**AERONAUTICAL CHARTING FORUM**  
**Instrument Procedures Group**  
**October 29, 2013**

**FAA Control # 13-02-312**

**Subject: Equipment Requirement Notes on Instrument Approach Procedures**

Fig 1A

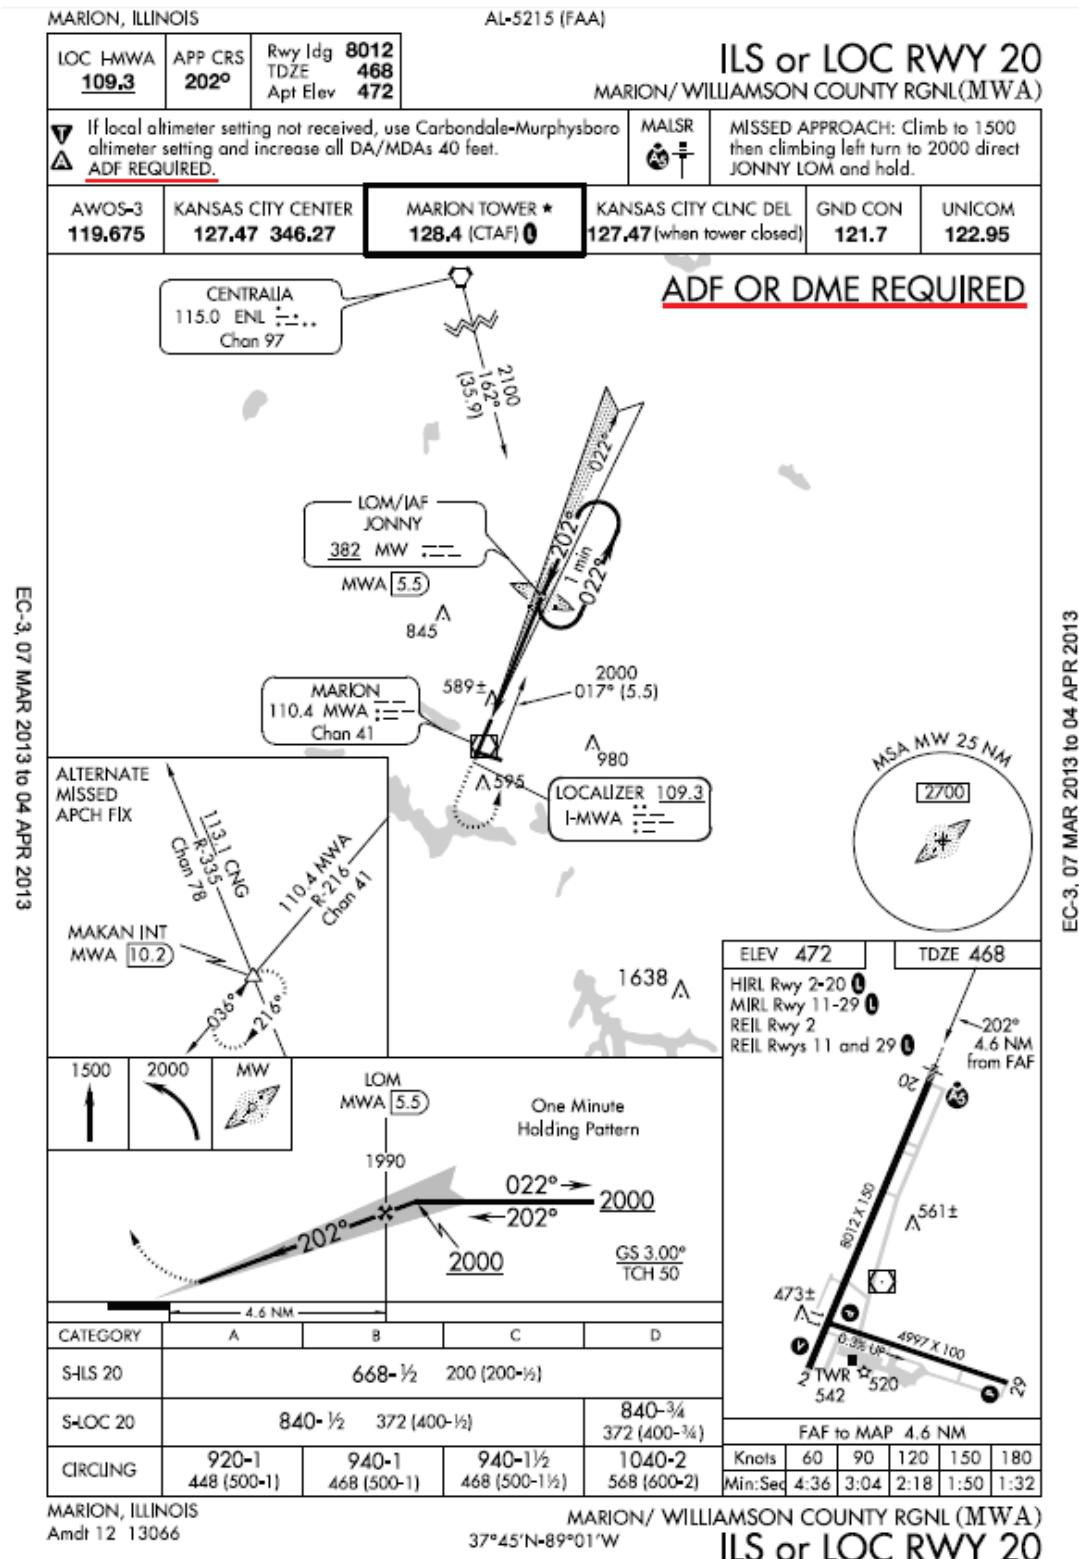
In certain cases, the application of these charting requirements can result in two separate equipment restriction notes on the same instrument approach charts (see Figures 1 **and 1A**, Marion IL - KMWA, ILS Runway 20). As can be seen on this example, there is a note in the briefing strip notes that states: "ADF Required". However, in the planview of this same chart there is a note stating: "ADF or DME Required". These two notes are confusing to the pilot since it is unclear whether ADF is really required, or can DME substitute for the ADF on this approach? The pilot has no way of determining immediately whether these notes are inclusive of either other (i.e. either ADF or DME is required) or whether they are mutually exclusive of each other (i.e. an ADF is always required).

2. Evaluate all requirements to execute the approach. Determine if any single aircraft equipment or navigation source (e.g. DME, Radar) is required for the approach and publish that requirement on the chart. For example, on the MWA ILS Rwy 20 approach, publish only “ADF Required”. The availability of DME is irrelevant to being able to fly this procedure since ADF is always required to fly the procedure.

FIG 2:

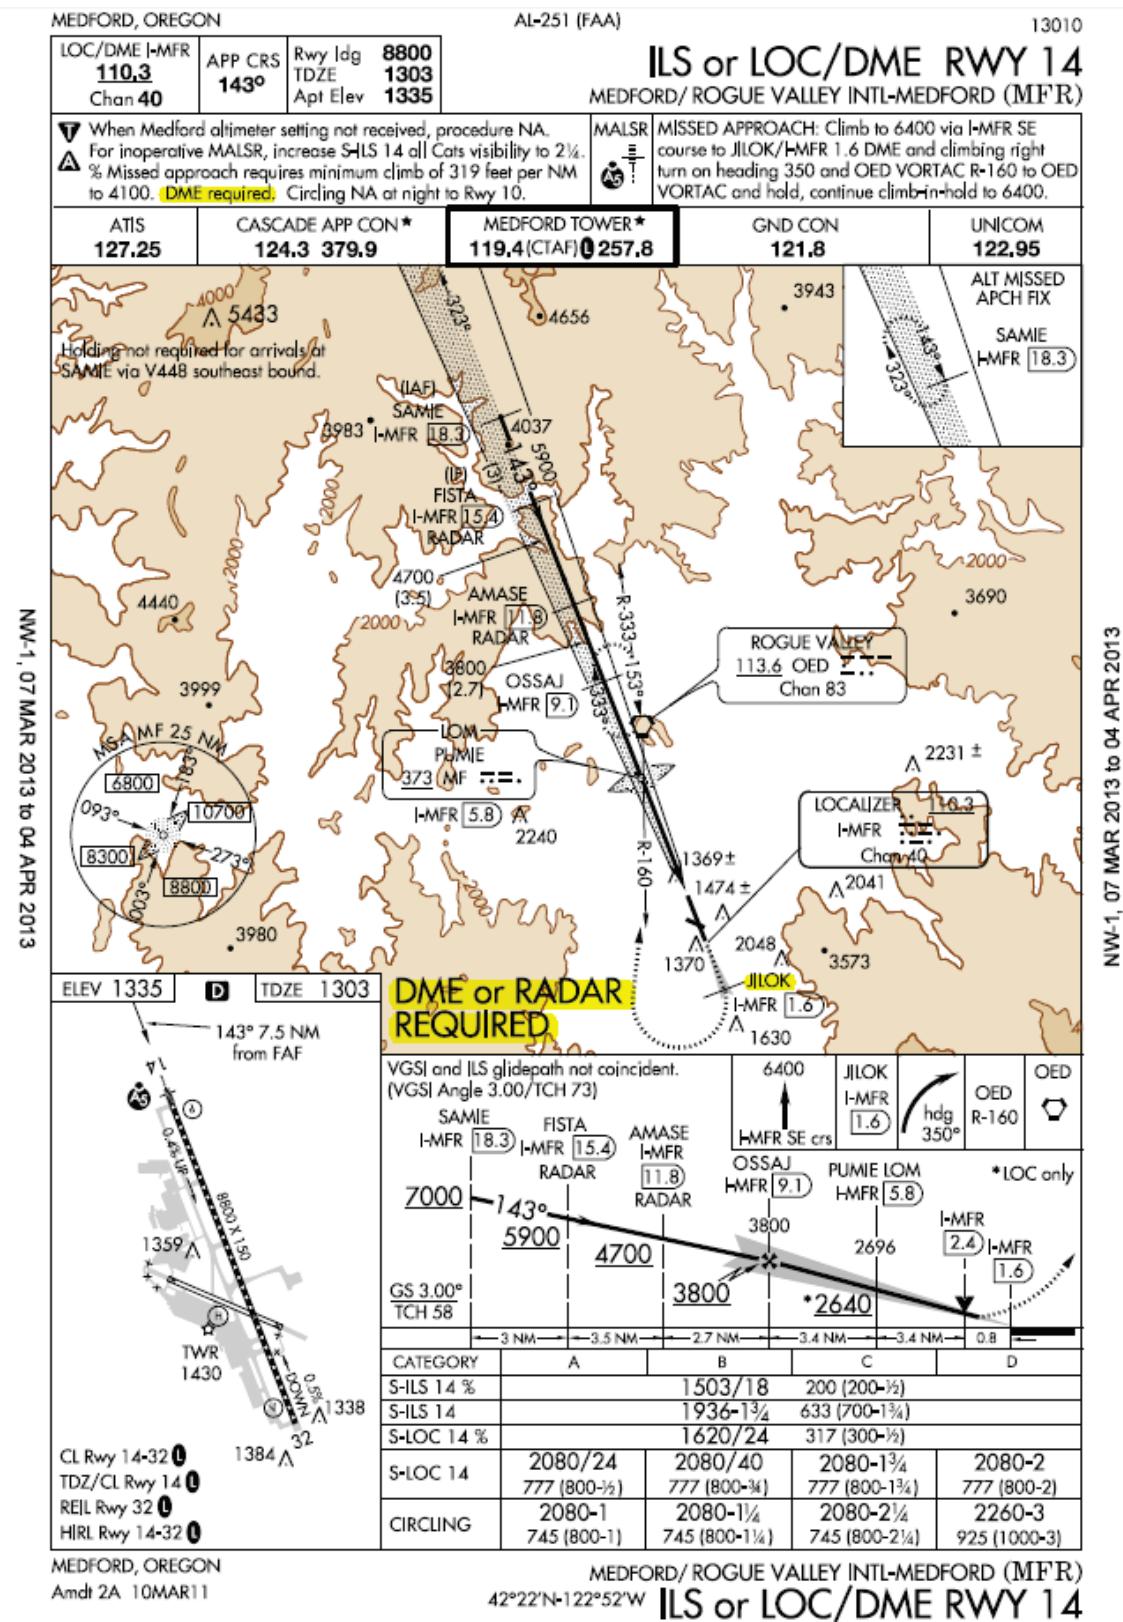
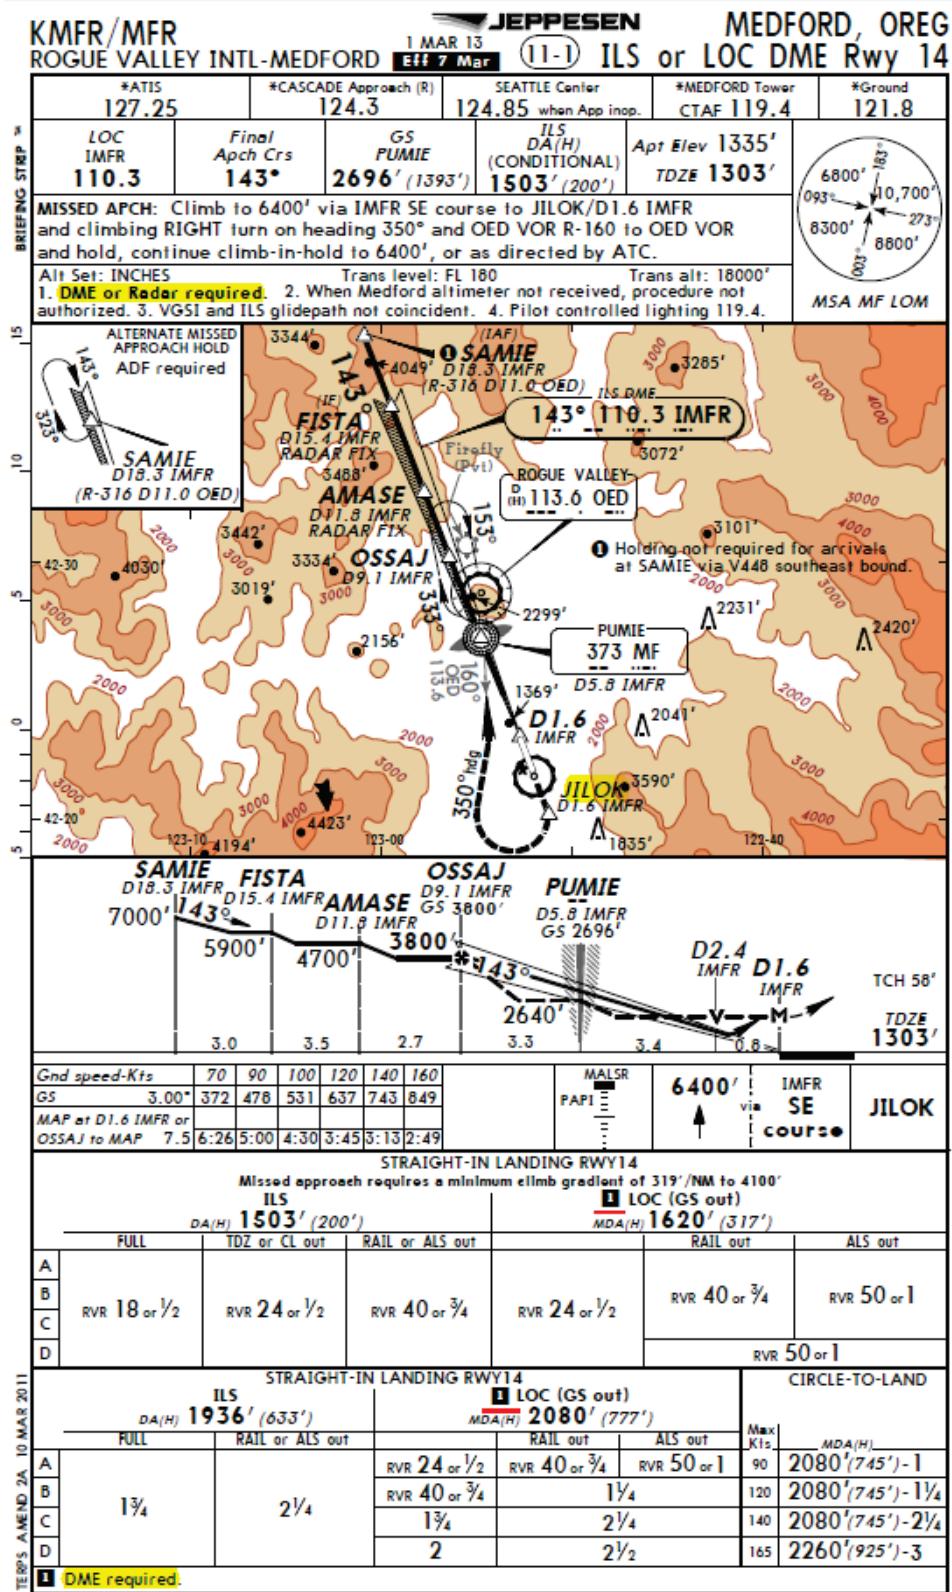
Medford, OR (KMFR) ILS or LOC/DME Runway 14 approach (Fig 2) provides another example of an approach with confusing notes. For this approach, a "DME required" is published in the Briefing Strip because DME is required to fly the missed approach procedure. The planview note, "DME or Radar Required" is published because DME or radar is required for procedure entry.

On a commercially produced version of this same procedure (see Fig 3), a "DME or Radar Required" note is published in the Briefing Strip. Note that this provider publishes the "DME Required" as a minima note associated with the LOC (GS-Out) line of minima. However, DME is required to execute the missed approach segment, regardless of whether the ILS minima or the LOC-only minima are used, and therefore applies to both the ILS and the LOC (GS-Out) lines of minima.
